ADDENDUM
NO. 3

April 17, 2026

**TRI-TOWNSHIP WANATAH SCHOOL
RENOVATION AND RELATED WORK
Wanatah, IN 46390**

This Addendum consists of Pages ADD 3-1 through ADD 3-4, and attached Addendum No. 3 from Gibraltar Design dated April 16, 2026 and consisting of 5 pages, replacement Specification Section 33 40 00 - Storm Sewage Systems, and 15 drawings.

© GIBRALTAR DESIGN SHEET
C-101

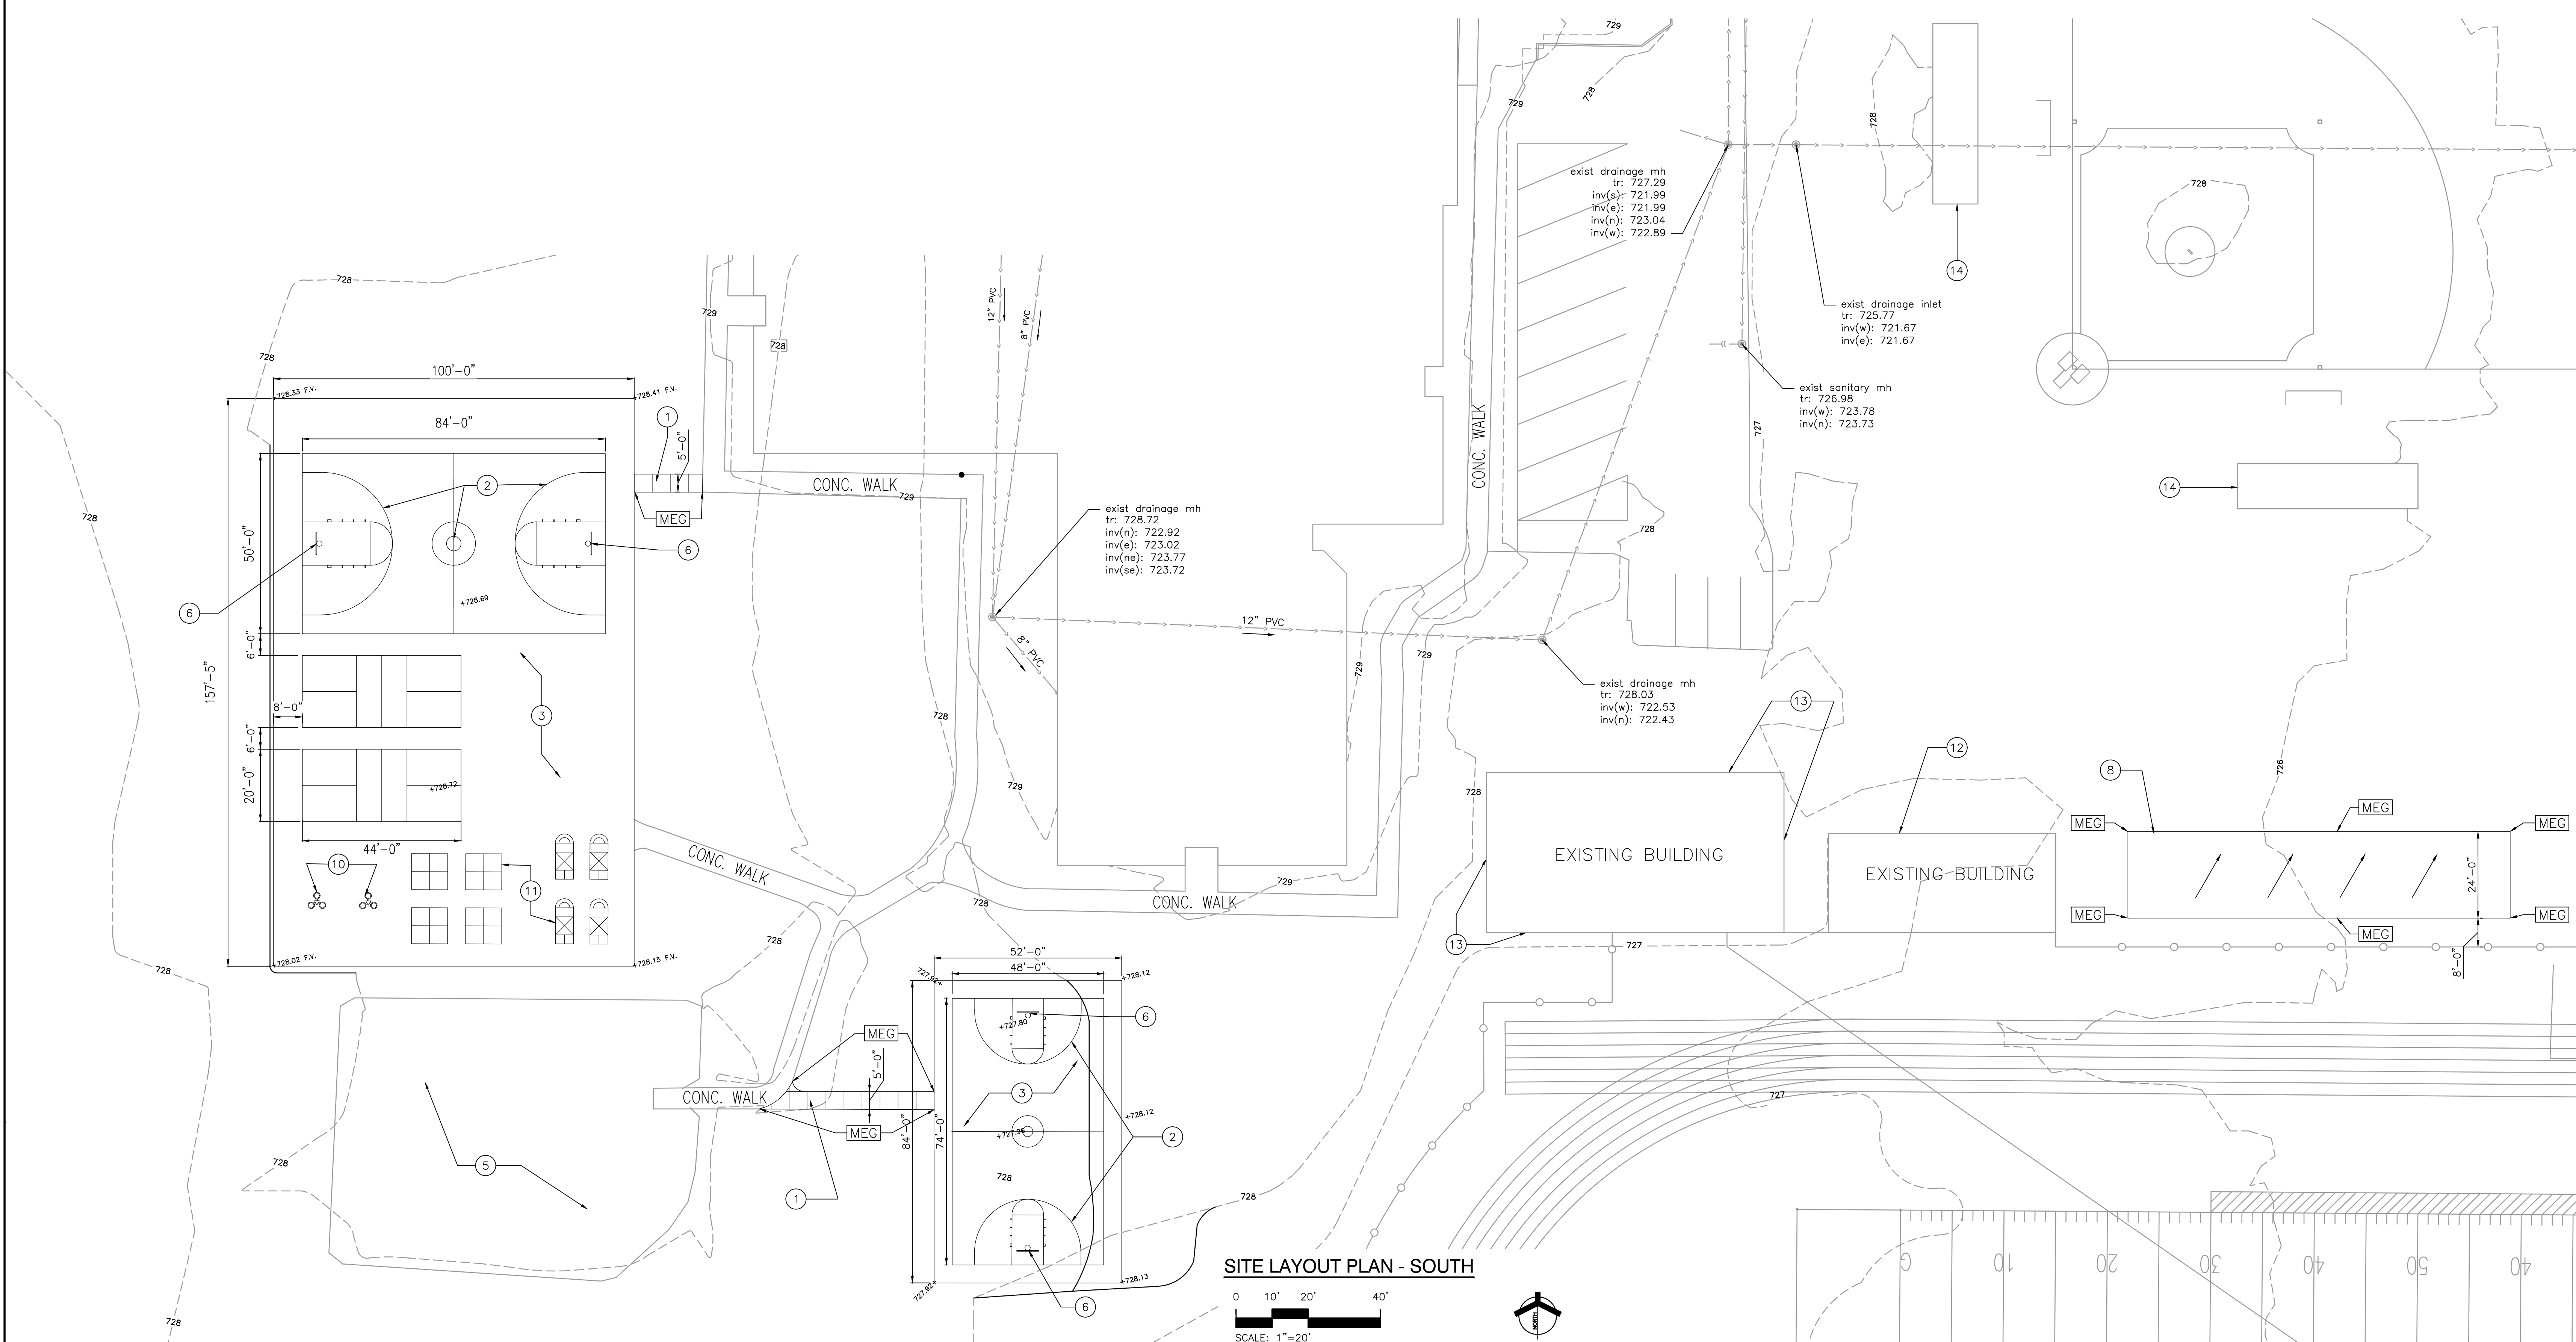
9. Sheet C-101

- A. Refer to revised, full-size drawing, for addition of Legend and correction of title, included in this Addendum, for clarifications.

GIBRALTAR DESIGN SHEET
C-102

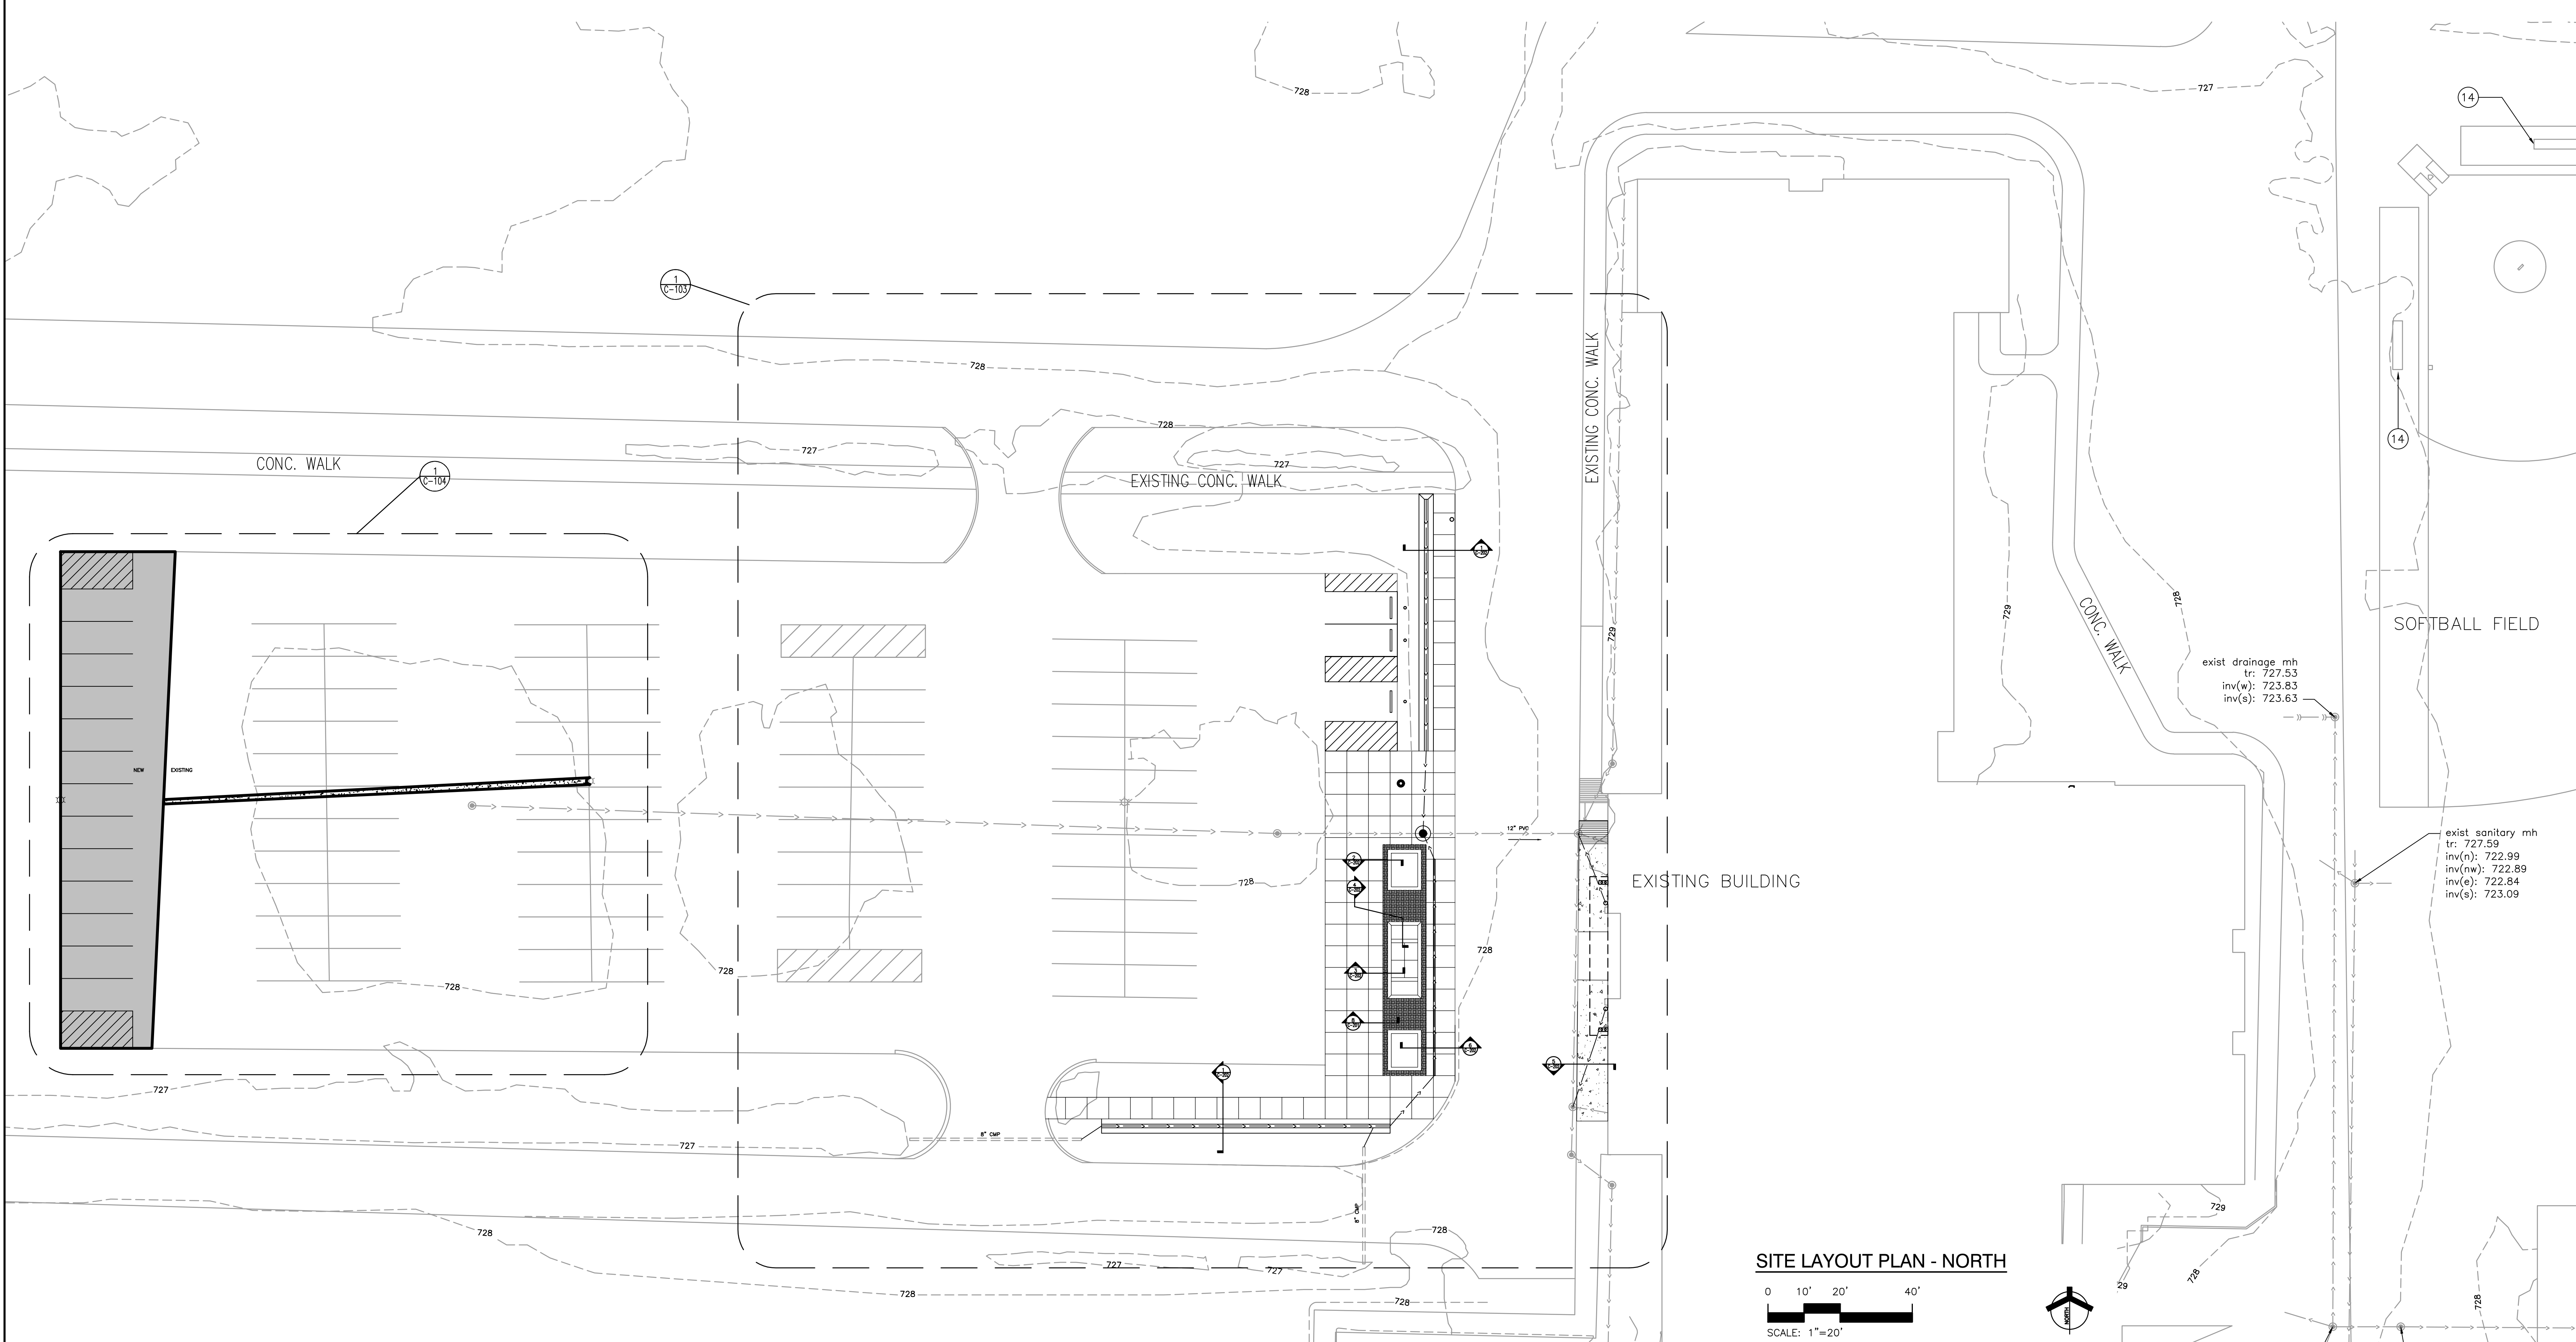
10. Sheet C-102

- A. Refer to revised, full-size drawing, for addition of Legend and correction of title, included in this Addendum, for clarifications.

© GIBRALTAR DESIGN SHEET
C-103

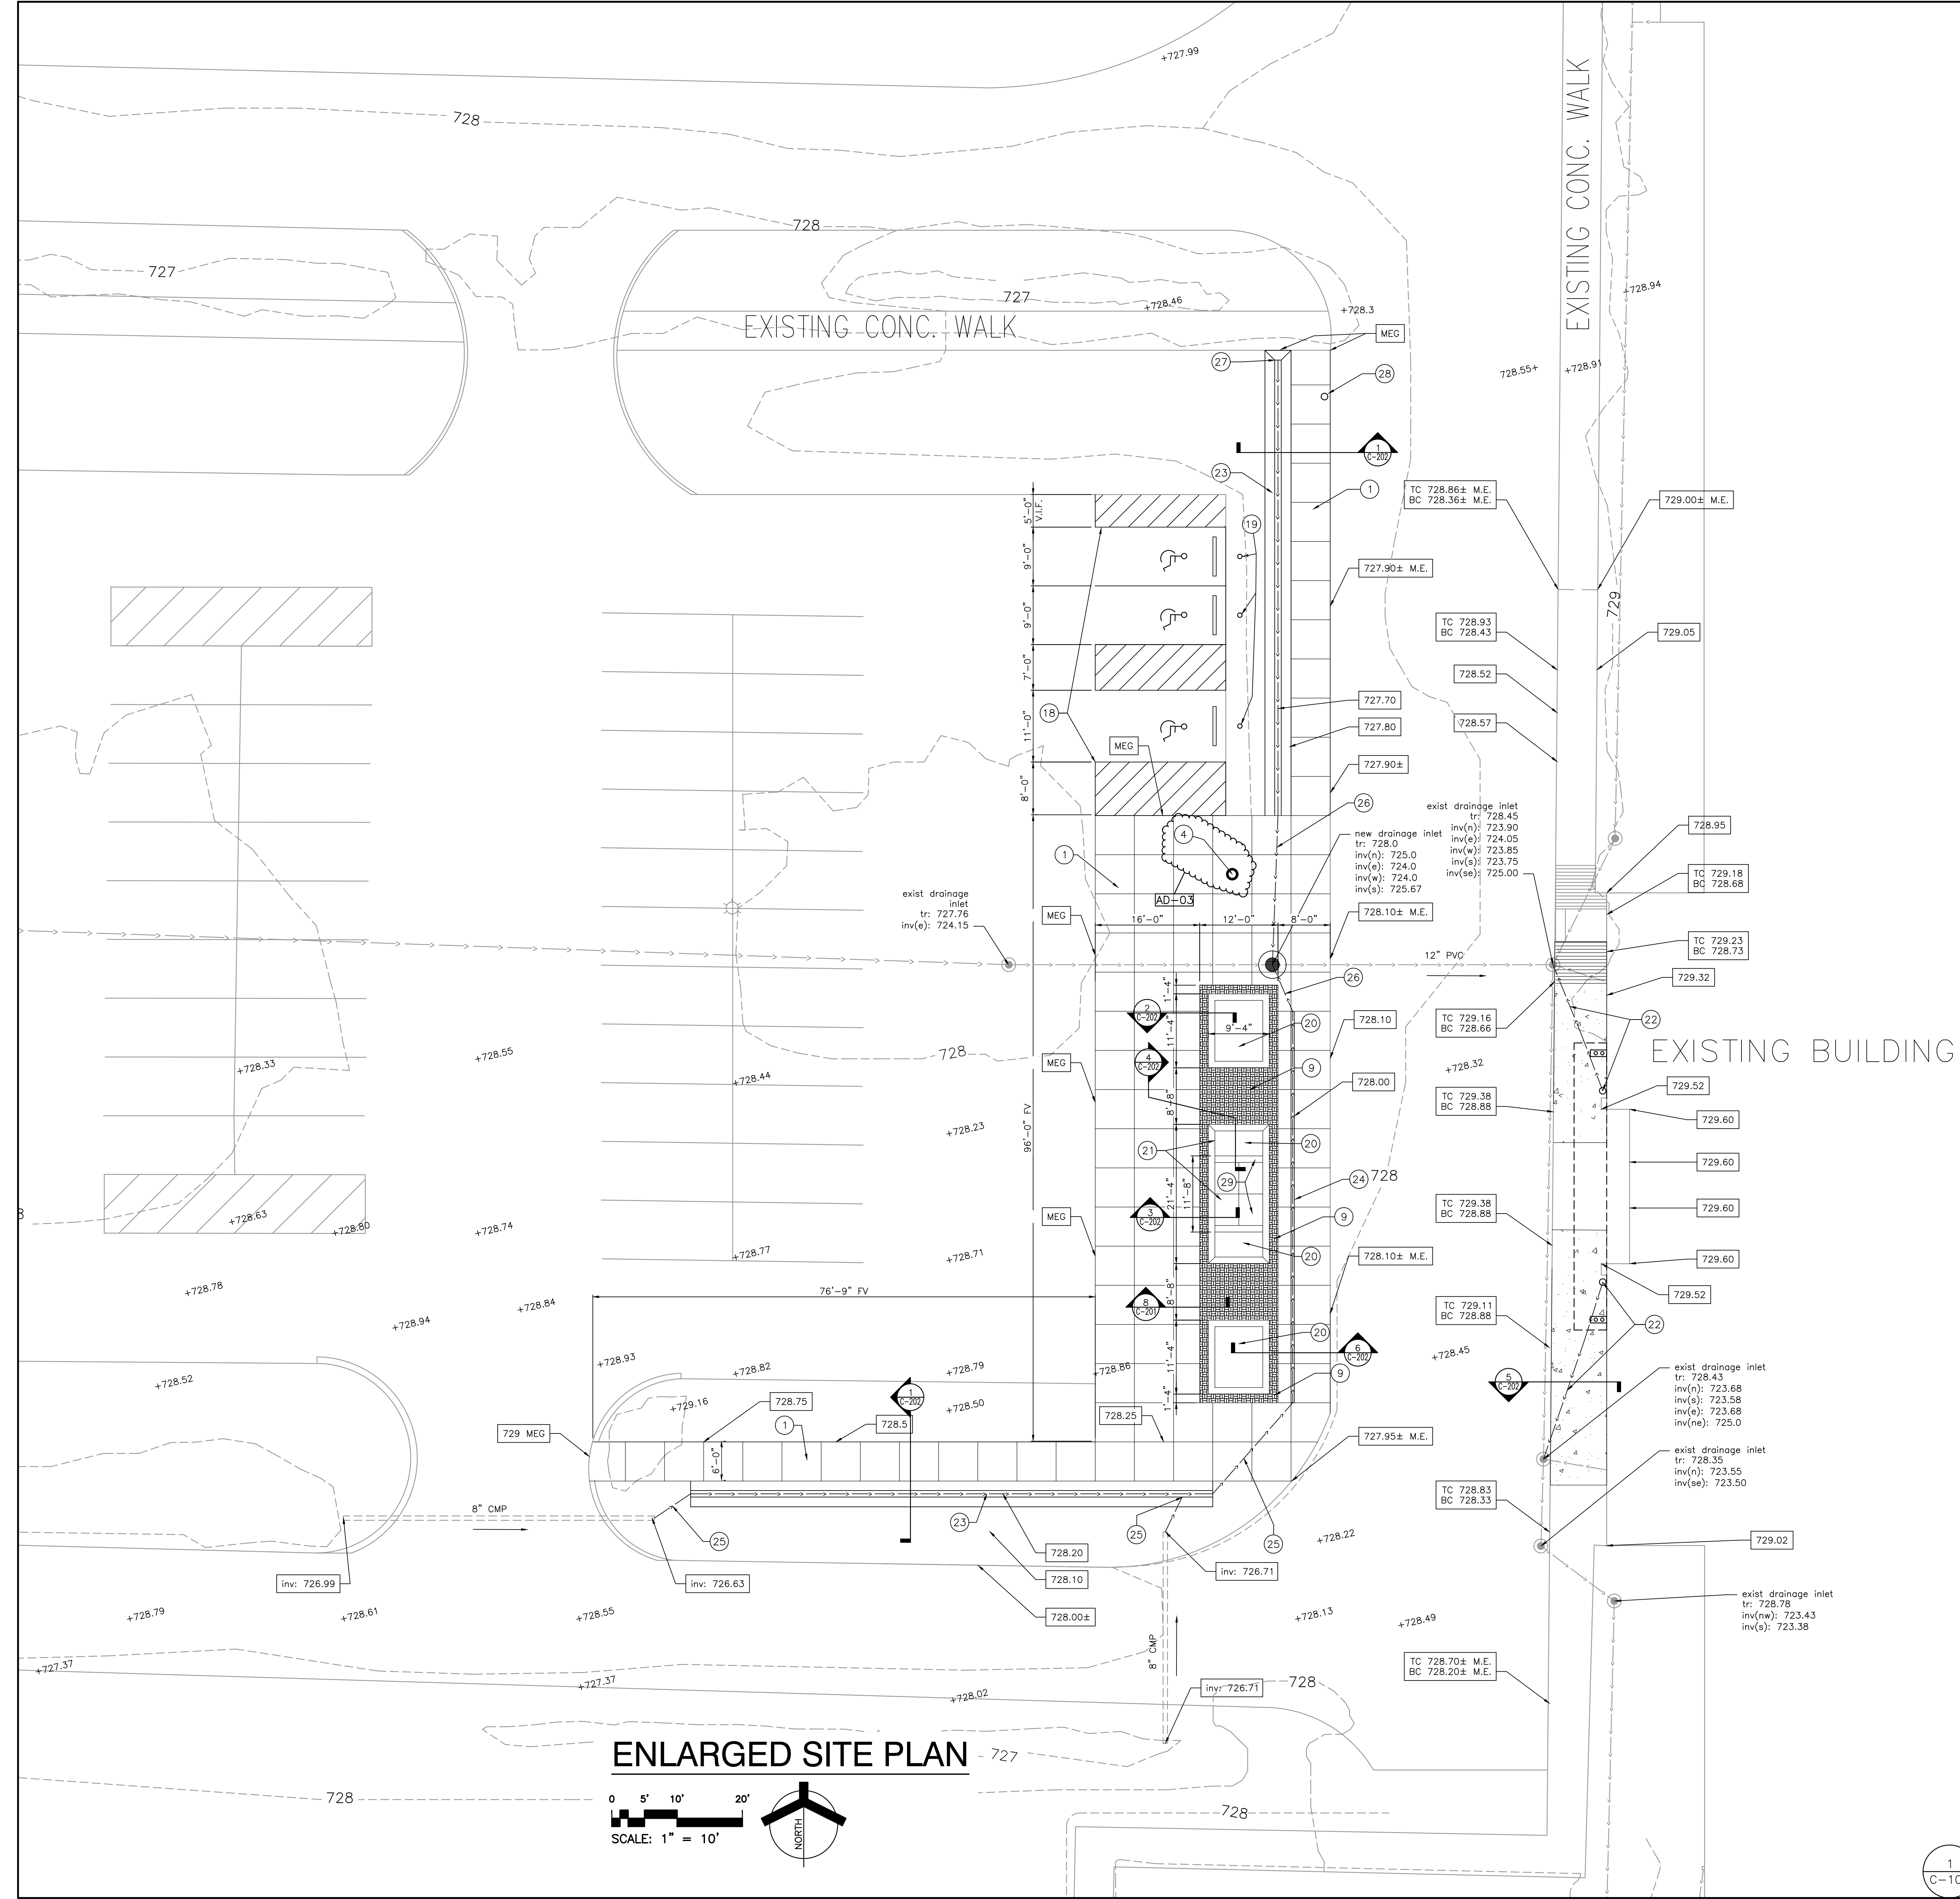
11. Sheet C-103

- A. Refer to revised, full-size drawing, for addition of Legend and correction Plan Note 4, included in this Addendum, for clarifications.
